Summerland

Planning Advisory Committee

SunPAC Meeting #8

May 7, 2008

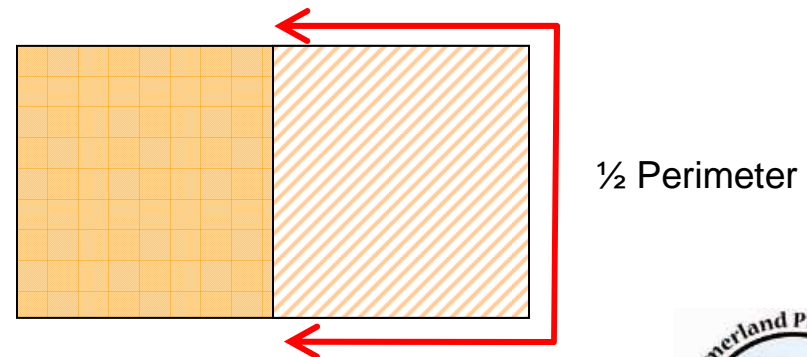
- Basement – Summerland: A basement shall be counted as a story if its floor-to-ceiling height is **6.5 feet** or more, and the finished floor directly above is **more than 4 feet above** the finished grade for more than **one-half of its perimeter**.

- Basement – Summerland: A basement shall be counted as a story if its floor-to-ceiling height is **6.5 feet** or more and the finished floor directly above is **more than 4 feet above** the finished grade

- Additional Building Height Guideline
 - 4.3 – Basements should be cut or dug into the grade. The use of excessive fill to qualify a portion of a structure as a basement is discouraged (Page 29)

- Chapter 4 – Building Scale and Form
 - Basements & FAR
 - Proposed Changes
 - Figure X - Basement

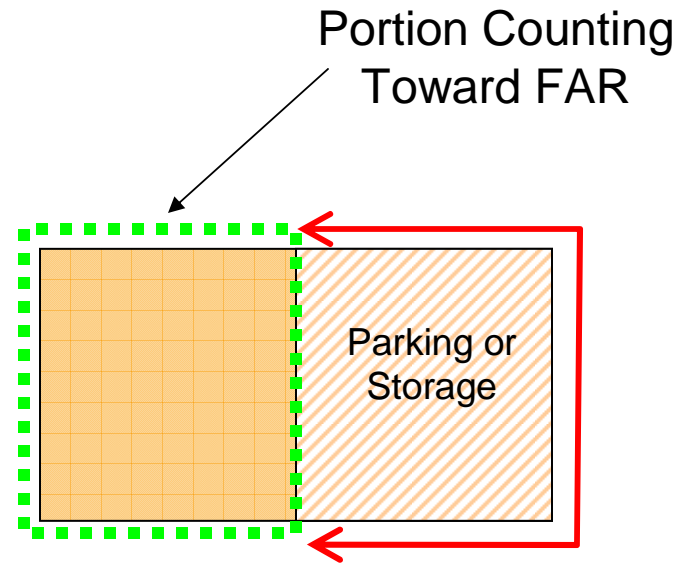
- Floor Area Ratio – Summerland: A measurement of development intensity represented by the quotient of net floor area divided by net lot area.
- Exclusions:
 - Parking and Storage located within, or portion of, a basement (see Figure X- Basement Illustration).

- Floor Area Ratio – Summerland: A measurement of development intensity represented by the quotient of net floor area divided by net lot area.
 - Exclusions:
 - Parking and Storage located within, or portion thereof, a basement (see Figure X- Basement Illustration)
- Basement – Summerland: A basement shall be counted as a story if its floor-to-ceiling height is 6.5 feet or more, and the finished floor directly above is more than 4 feet above the finished grade.
- Additional Building Height Guideline
 - 4.3 – Basements should be cut or dug into the grade. The use of excessive fill to qualify a portion of a structure is discouraged. (Page 29)

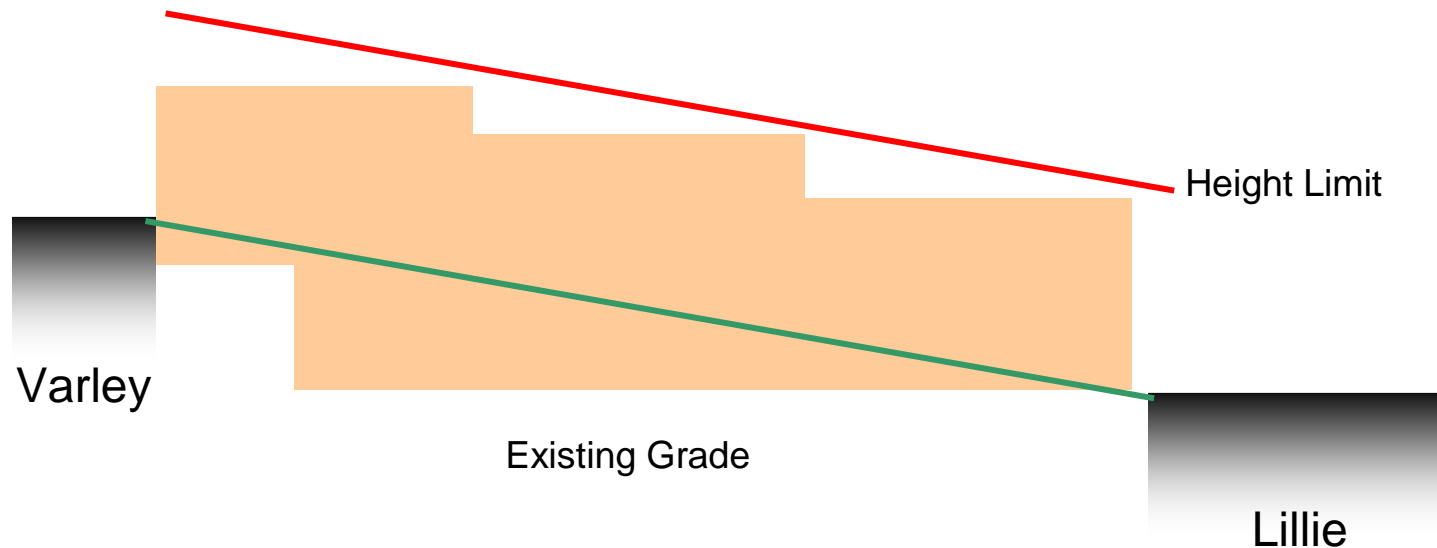
- Chapter 4 – Building Scale and Form
 - Building Height Discussion
 - Proposed Building Height Methodology
 - As slope increases, design flexibility is increased, allowing the ability for the structure to cut into the slope.

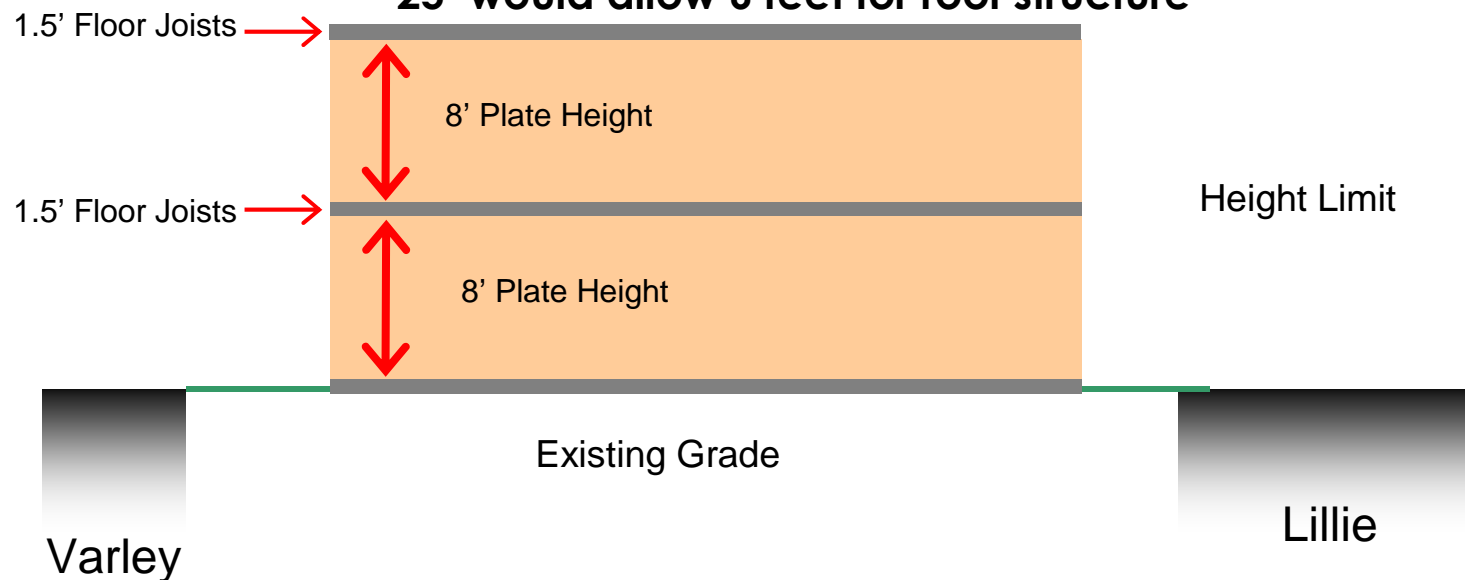
- Chapter 4 – Building Scale and Form
 - Building Height Discussion
 - Proposed Building Height Methodology
 - Two story structure, without roof is at 19 feet
 - **22' - 19' = 3 feet remaining for roof structure**
 - **25' would allow 6 feet for roof structure**

- Chapter 4 – Building Scale and Form
 - Staff Recommendation
 - Adopted County Height Methodology
 - Change the Building Height in the C-1 to 25 feet, consistent with the County Coastal Area
